Model: Model AT-C1		Date: 5-Jun-06	No.: MB230001
Modified Article: Parts Catalog Correction		Prepared by: K. Hamada	
From: 1st Tech. Support Sec. Service Support Dept.			
Reason for Modification:	☒ Parts catalog correction ☐ Vendor change ☐ Other ☐ To facilitate assembly ☐ To improve reliability ☐ To meet standards ☐ Part standardization ☐ Product Safety ()

Change/Reason: The index was corrected.

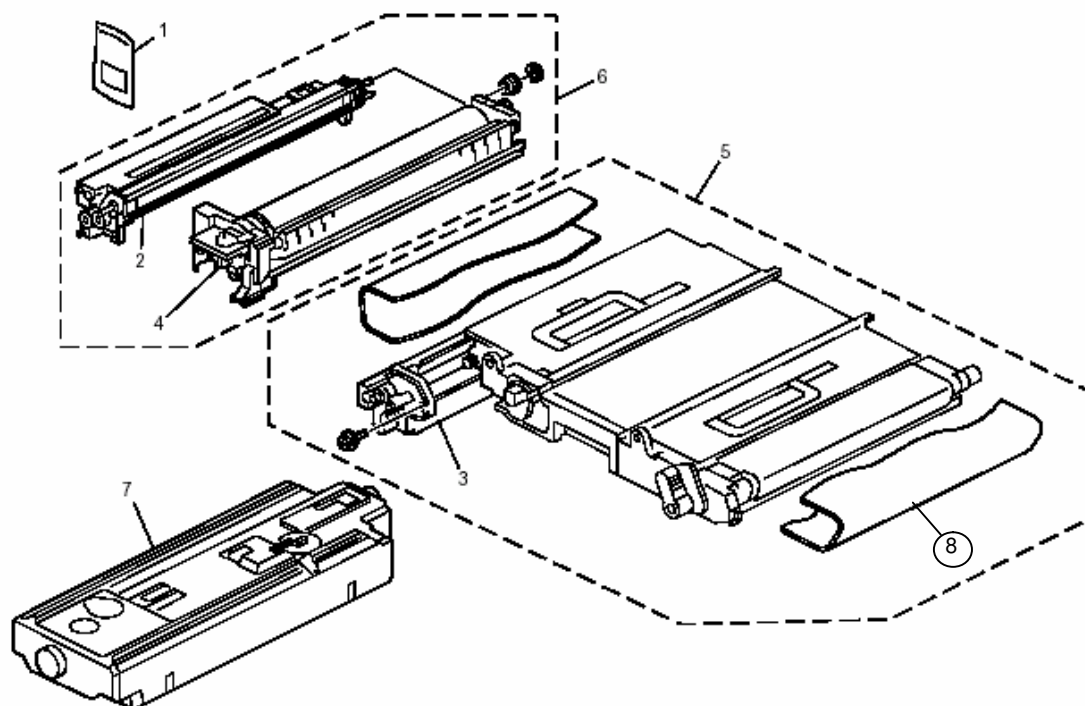
Part number	Description	Page	Incorrect Index	Correct Index	Note
AE020156	Pressure Roller	51	4	14	
AE012030	Heat Roller: Dia25: Coat	51	14	4

19.PCU/Transfer Unit (B230B237)

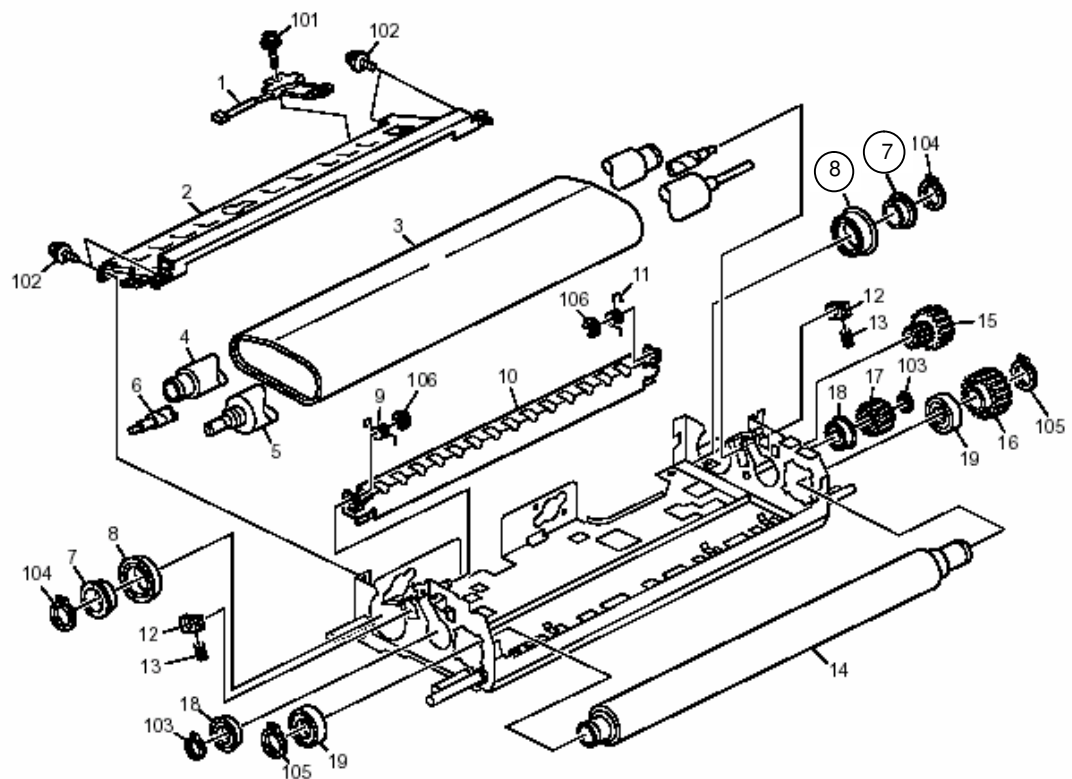
Old part number	New part number	Description	Q'ty	Int	Page	Index	Note
B2236020	B2236022	Image Transfer Belt Unit			47	5	*1
	B2306130	Image Transfer Belt			47	8	*2
	AX440245	Heater - 116V 700W/500W			49	1	*2
	AX430164	Heater - 116V 250W			49	2	*2
	AE032030	Bushing - 20x25			51	7	*3
	AE030066	Ball Bearing: 25x32x7			51	8	*3
AE030068	AE030067	Ball Bearing: 17x26x5			51	19	*1

- 1) The parts in the table labeled “*1”: The P/N was corrected.
- 2) The parts in the table labeled “*2”: These parts were missing from the Parts Catalog.
- 3) The parts in the table labeled “*3”: The index number was corrected.

19.PCU/Transfer Unit (B230B237)

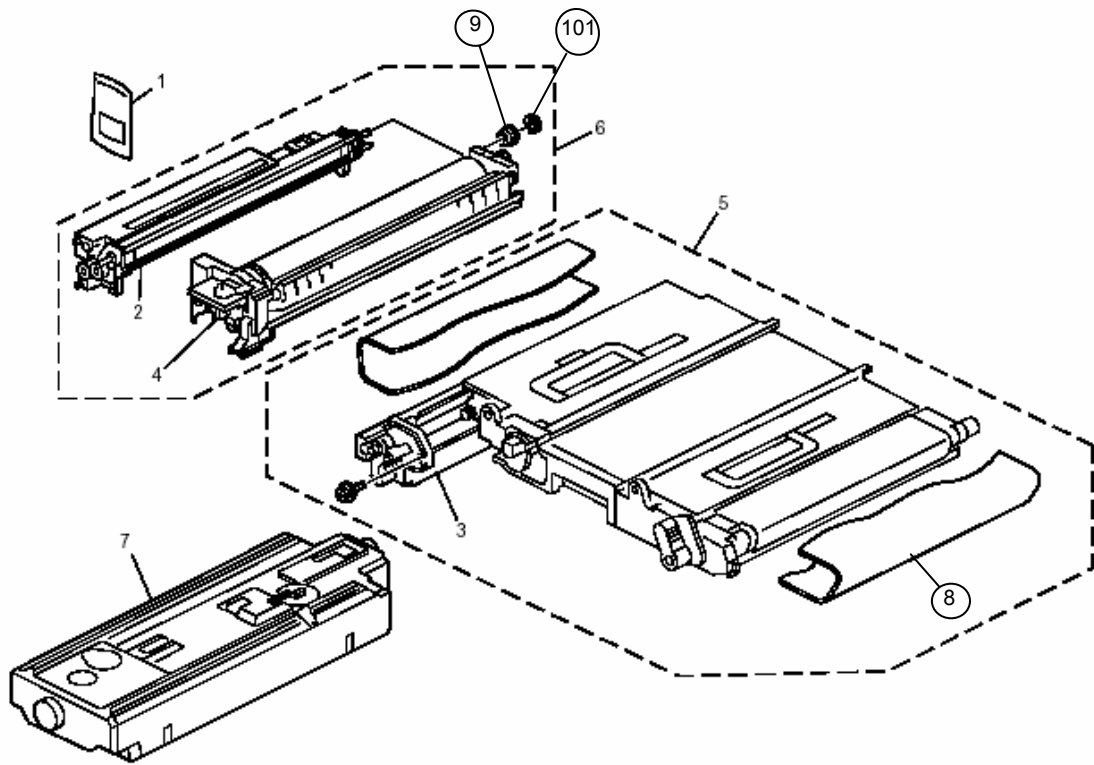
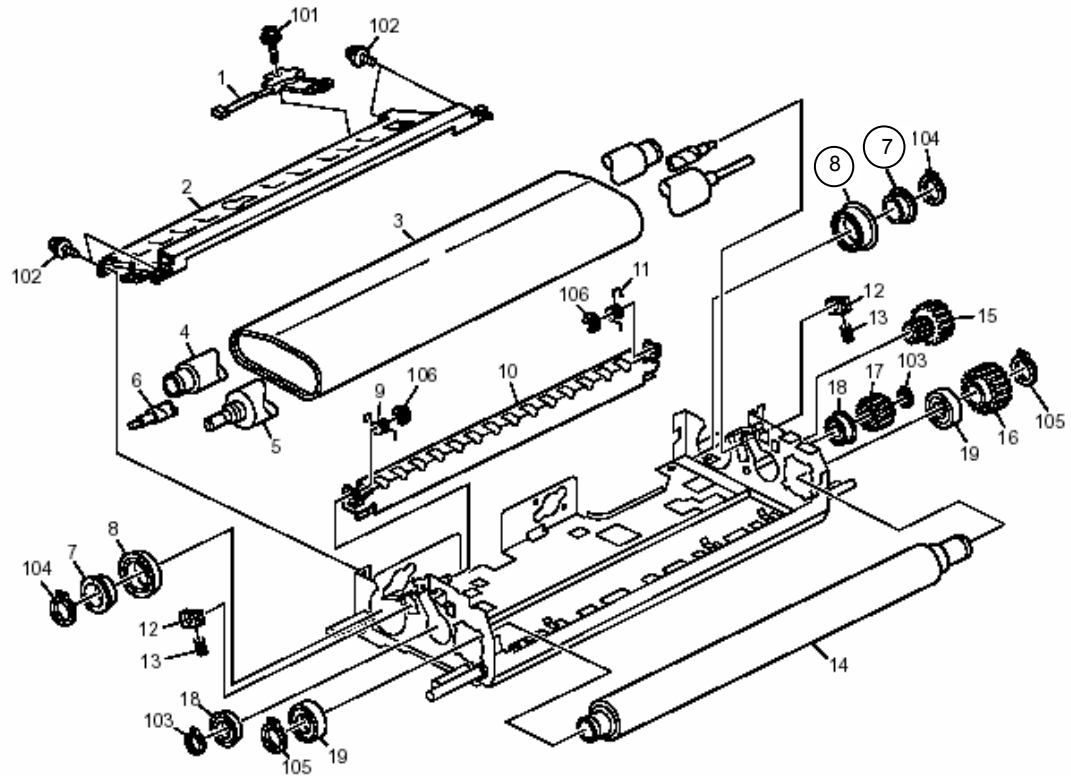
Old part number	New part number	Description	Q'ty	Int	Page	Index	Note
B2236020	B2236022	Image Transfer Belt Unit			47	5	*1
	B2306130	Image Transfer Belt			47	8	*2
	AX440245	Heater - 116V 700W/500W			49	1	*2
	AX430164	Heater - 116V 250W			49	2	*2
	AE032030	Bushing – 20x25			51	7	*3
	AE030066	Ball Bearing: 25x32x7			51	8	*3
AE030068	AE030067	Ball Bearing: 17x26x5			51	19	*1
	AA084000	<i>Bushing: Dia6</i>			47	9	*2
	07200040E	<i>Retaining Ring M4</i>			47	101	*2

- 1) The parts in the table labeled “*1”: The P/N was corrected.
- 2) The parts in the table labeled “*2”: These parts were missing from the Parts Catalog.
- 3) The parts in the table labeled “*3”: The index was corrected.

19.PCU/Transfer Unit (B230B237)

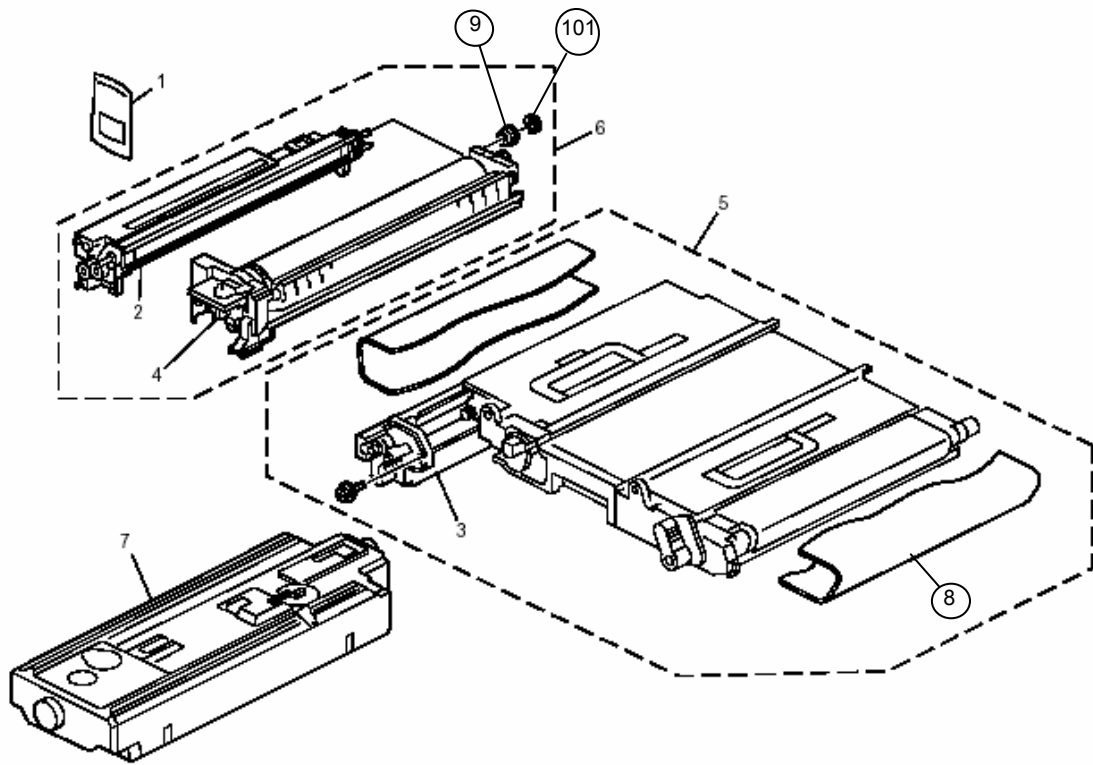
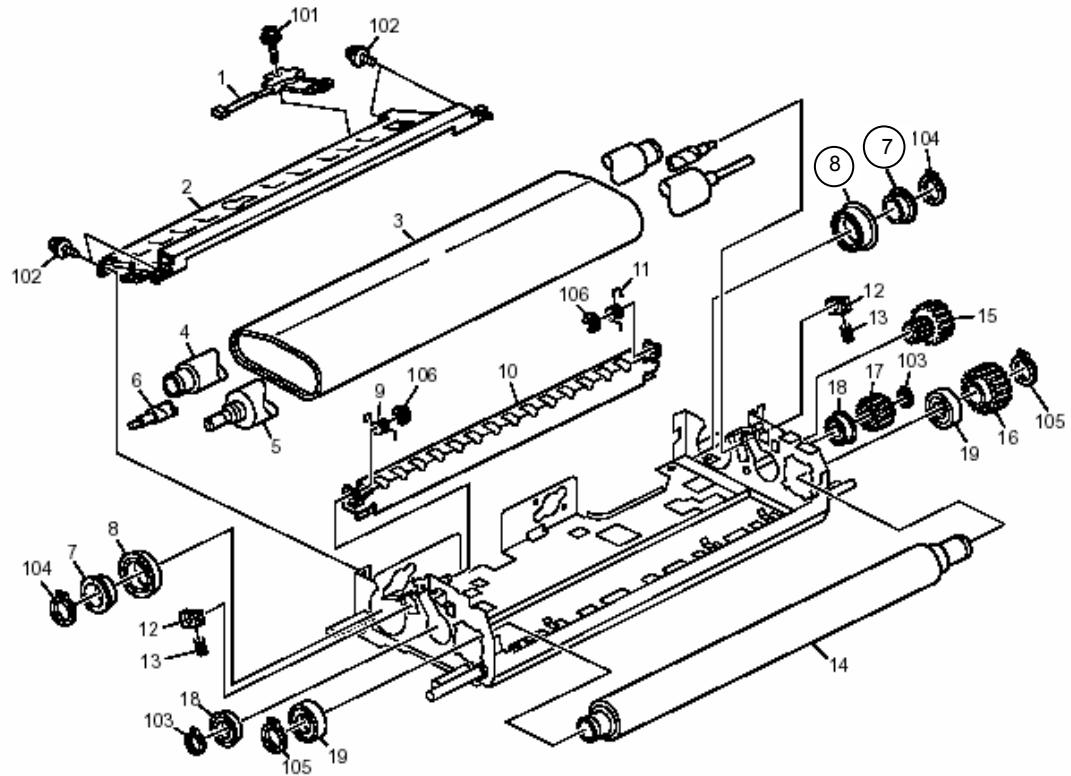
Old part number	New part number	Description	Q'ty	Int	Page	Index	Note
B2236020	B2236022	Image Transfer Belt Unit			47	5	*1
	<i>B2236130</i>	Image Transfer Belt			47	8	*2
	AX440245	Heater - 116V 700W/500W			49	1	*2
	AX430164	Heater - 116V 250W			49	2	*2
	AE032030	Bushing – 20x25			51	7	*3
	AE030066	Ball Bearing: 25x32x7			51	8	*3
AE030068	AE030067	Ball Bearing: 17x26x5			51	19	*1
	AA084000	Bushing:Dia6			47	9	*2
	07200040E	Retaining Ring M4			47	101	*2

- 1) The parts in the table labeled “*1”: The P/N was corrected.
- 2) The parts in the table labeled “*2”: These parts were missing from the Parts Catalog.
- 3) The parts in the table labeled “*3”: The index was corrected.

19.PCU/Transfer Unit (B230B237)

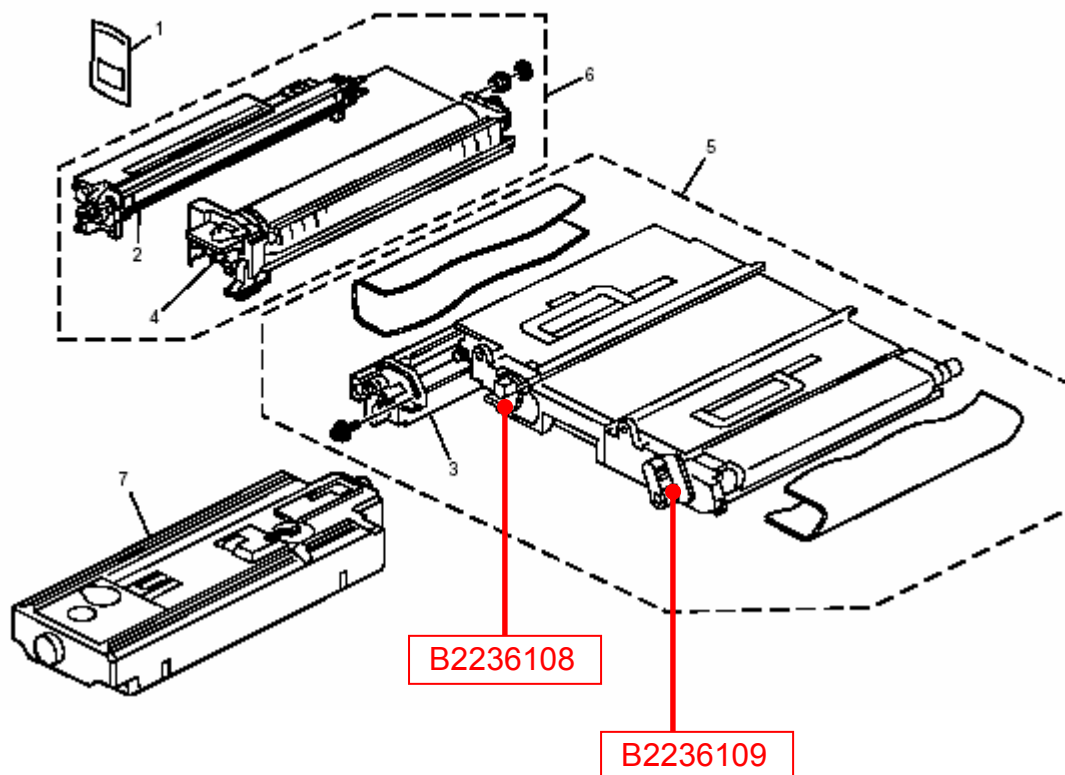
NOTE: * is new part number.

Reason: These parts are required as service parts.
